TO: Development Review Board
FROM: Scott Gustin *SG*
DATE: February 17, 2015
RE: 15-0734CA/CU; 502 North Street

Request: Rear addition to home, driveway expansion, and creation of accessory apartment

DODSON RESIDENCE
502 NORTH STREET
DESIGN ADVISORY BOARD SUBMISSION
JANUARY 14, 2015

4500 Series Stainless Steel Standard Vertical Mailbox

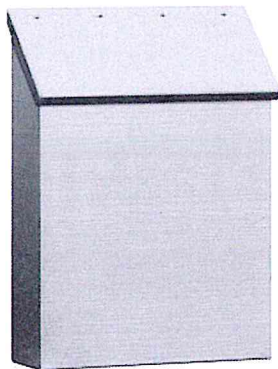
No new utility lines are proposed. The apartment will not be separately metered. No ground-mounted mechanical equipment is proposed. The revised project plans depict a mailbox location on next to the mudroom door; however, the application notes that mail will be delivered into a slot in the mudroom door. This minor discrepancy needs to be clarified. **(Affirmative finding as conditioned)**

1. **Prior to release of the zoning permit**, the exterior mail box vs. mudroom door mail slot shall be resolved, and edging material for the gravel parking shall be noted on the site plan. Revised plans shall be subject to staff review and approval.

A-101

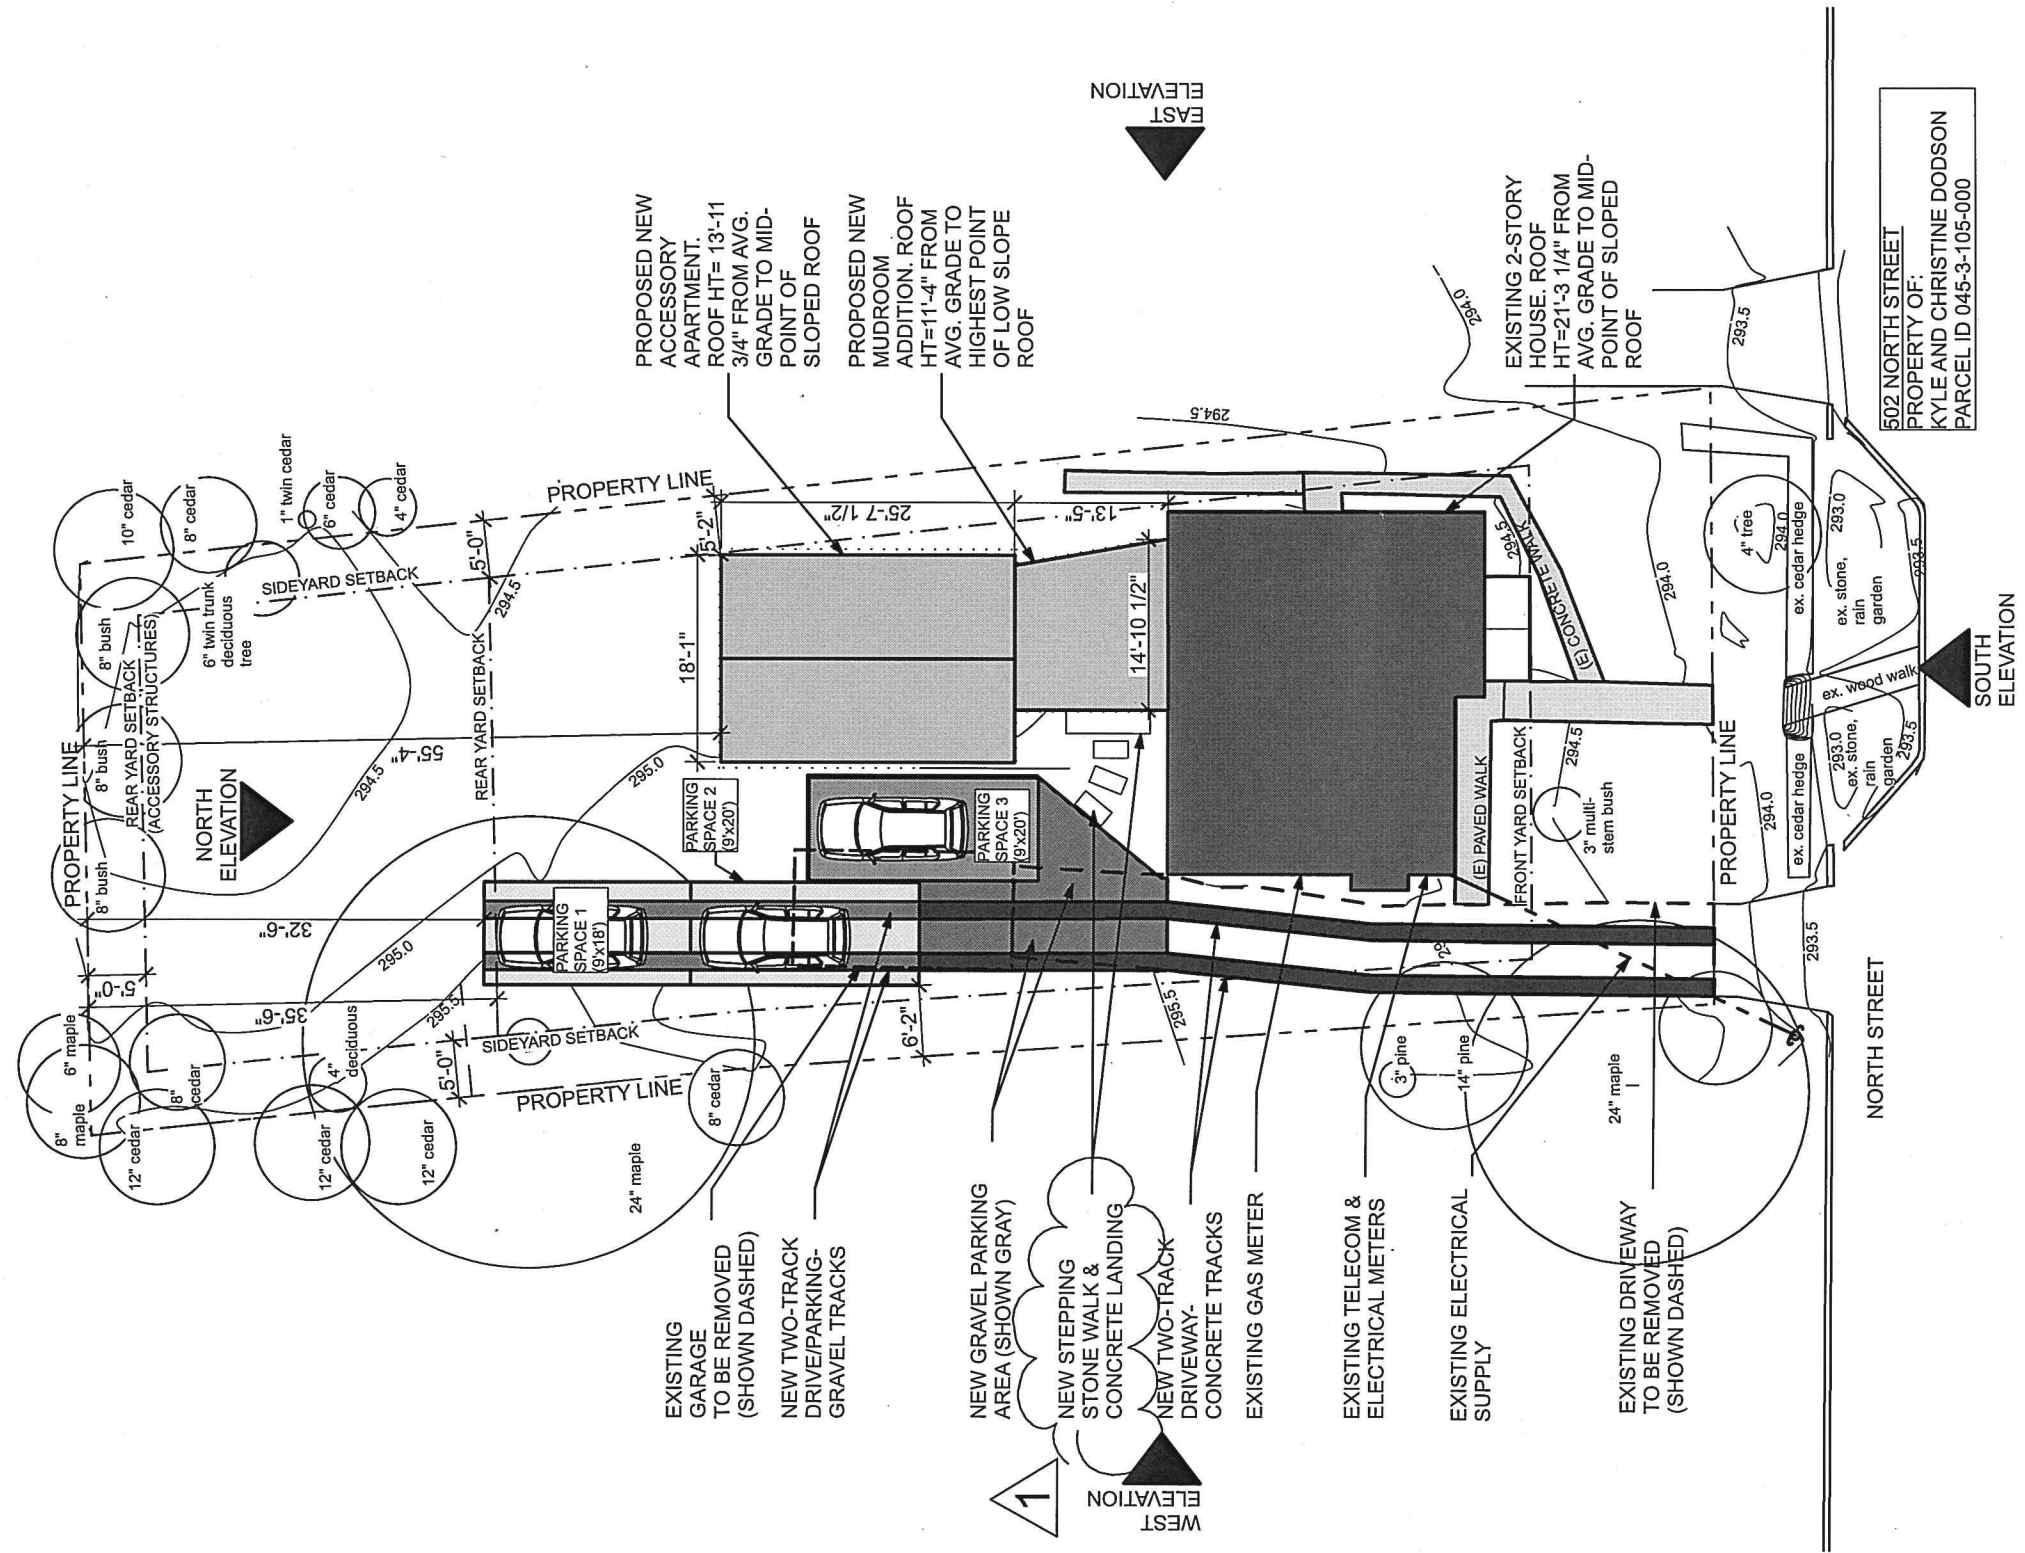
The revised site plans eliminate the previous discrepancy in lot coverage. The property is 7,277 sf and presently has 31.7% lot coverage. Within the RL zone, up to 35% lot coverage is permissible with an additional 10% allowable for things such as walkways, decks, and patios. With the construction of new lot coverage and removal of some existing lot coverage, proposed lot coverage will be 37.1%. This amount includes 32.7% standard lot coverage and 4.3% additional lot coverage allowed for walkways and stair landing area. This coverage is acceptable.

The width of the property varies between 52' and 48' wide. The minimum required side yard setback may be 10% of the lot width (or the average of neighboring properties). The site plan depicts a compliant side yard setback for the proposed construction of 5' 2" from the nearer side property line. The 136' deep property requires a 34' rear yard setback (25% of the depth). The site plan depicts a compliant 55' 4" rear yard setback. The reconstructed driveway adheres to existing or increased side yard setbacks and is acceptable. The front yard setback will remain unchanged.
